屯門區區內不合標準和缺乏連接的行人路

Missing and sub-standard pedestrian connections in the Tuen Mun District

Paul Zimmerman, CEO of Designing Hong Kong

2.

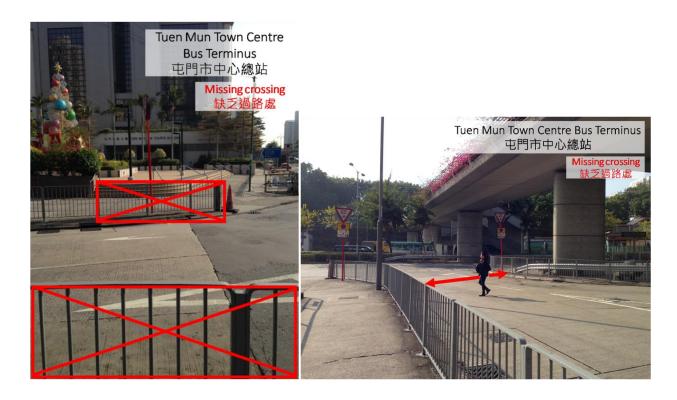
Location: The junction between Tuen Mun Centre Bus Terminus and Tuen Mun Law

Courts Building

Category: Missing crossing

Description: Missing crossing to connect with Tuen Mun Law Courts Building

Suggestion: Remove railings and provide a cautionary crossing with road markings and

dropped kerb
